Agenda
Planning Commission
Wednesday, 21 August 2019 – 7:00 P.M.
City Hall – Council Chambers, 1 S Huron St
Ypsilanti, MI 48197

Staff Review of Site Plan & Special Use Application
422 N Hamilton Renovation
422 N Hamilton

Regarding: **422 N Hamilton Street**
Site Plan Review No. 1
OHM Job No. 0094-19-1000

Regarding: **Cultivate Coffee & Tap House**
Site Plan Review No. 3
OHM Job No. 0094-18-1030

Figure 2: Site Aerial (2010)

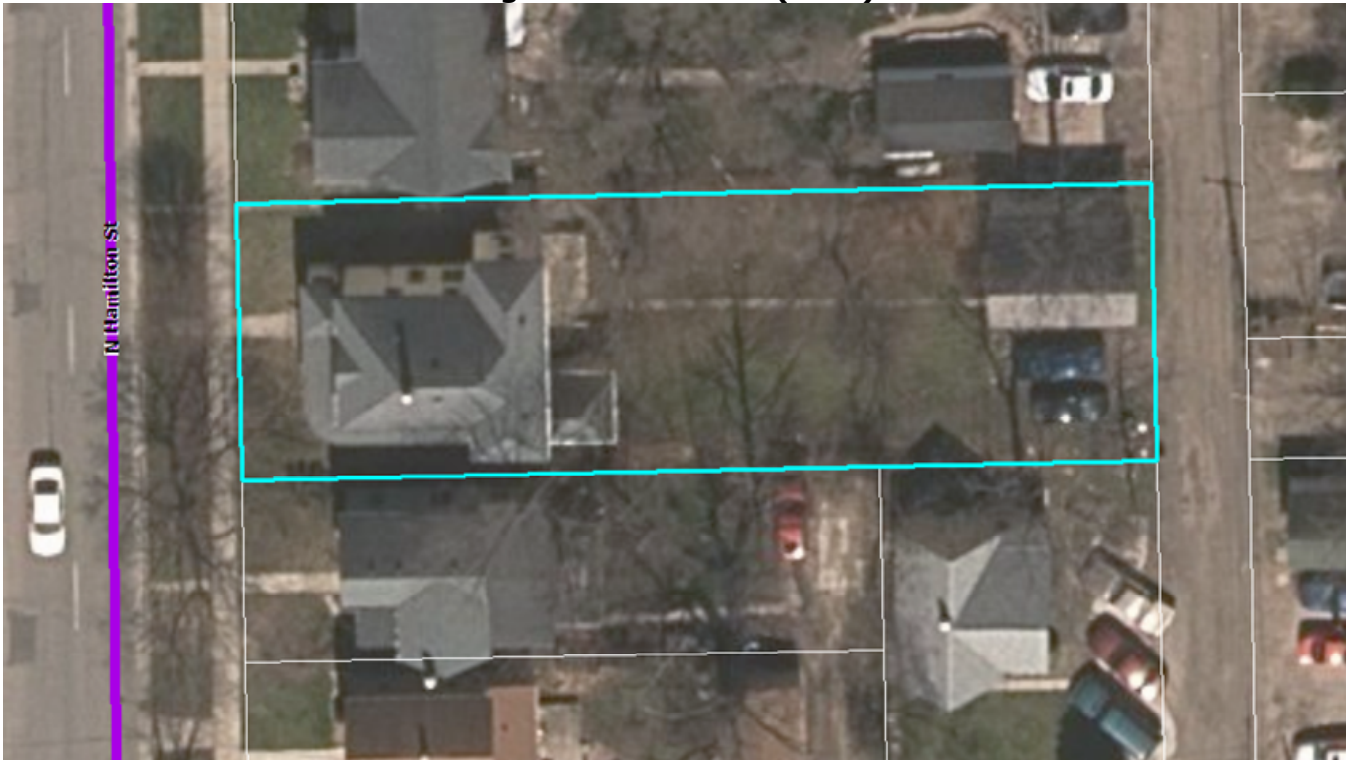
Note that the backyard is largely vegetated currently, and there is room for 2-3 vehicles with the current configuration.

SHEET + TITLE
SITE PLAN

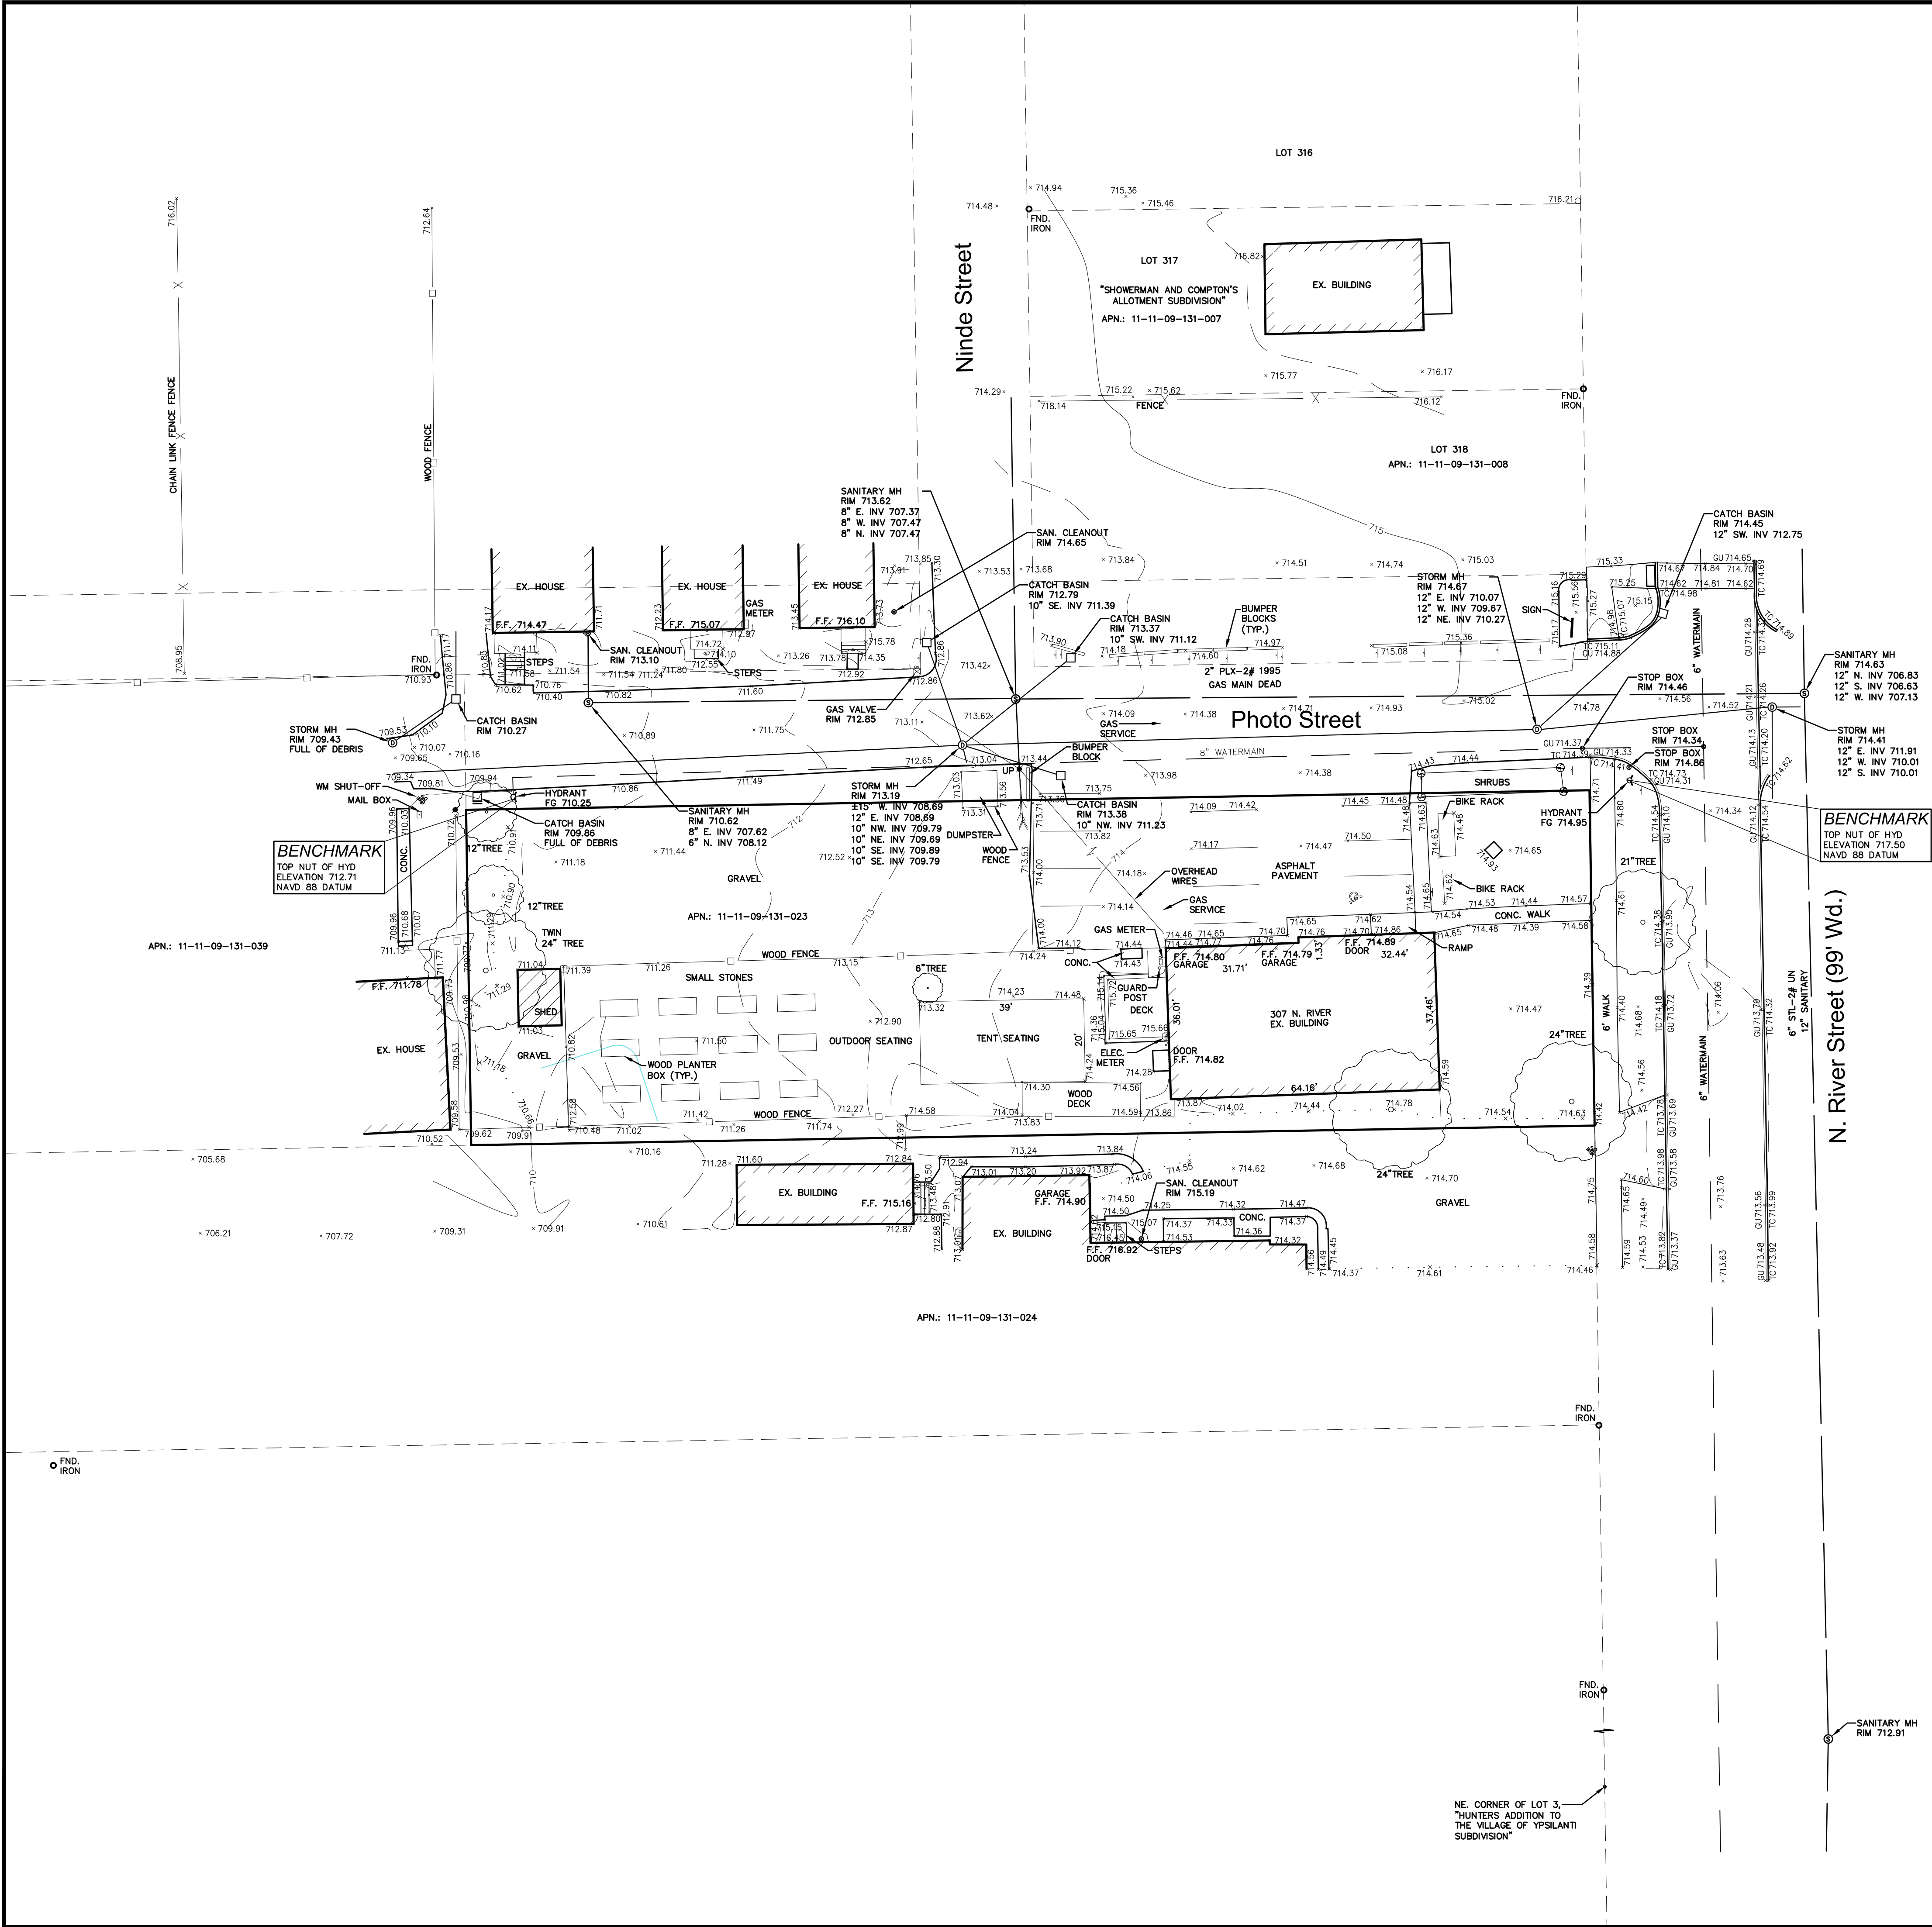
1. Applicant shall provide grades at all property corners and along the property lines.
2. Sheet "SP1.00 Site Plan" shows a different ramp layout at the southwest corner of the building than sheet 2 "Site Plan". Applicant shall confirm which ramp layout is being proposed.

3. Proposed top of walk grade of "7714.60" near the canopy at the northeast corner shall be revised.
4. Per ADA requirements, a van accessible parking space is a minimum of 11 feet wide. The barrier free parking space on the proposed site plan is only 10.5 feet wide. The applicant shall revise accordingly.

5. Applicant shall provide a truck turn plan to ensure proposed dumpster location can accommodate a standard garbage truck.
6. Provide "no parking fire lane" sign on north property line, east of the proposed dumpster location to maintain hydrant access.

7. The applicant shall provide ADA compliant sidewalk ramp details on the plans (i.e. MDOT R-28 series, etc.).
8. The applicant shall clarify where existing utility pole guy wires will be moved to. The current plans show guy wires going into the sidewalk.

9. The current plan proposes swales at the northwest corner of the property to convey water to an existing road catch basin. According to the plans, this catch basin is full of debris and the topographic survey does not show where this water is ultimately flowing in underground pipes. Stormwater management performance shall be brought up to the current Washtenaw County Water Resources Commissioner's (WCWRC) Standards for the site. Variances may be requested when it can be demonstrated that this standard cannot be feasibly accommodated. The applicant shall provide a preliminary stormwater narrative on the plans that includes a comparison of existing impervious surface area at the site and the proposed development. The narrative shall include a description of the proposed Best Management Practices (BMPs). All BMPs shall be clearly shown and labeled on the plans. The applicant shall also provide preliminary stormwater calculations in accordance with the WCWRC Standards.
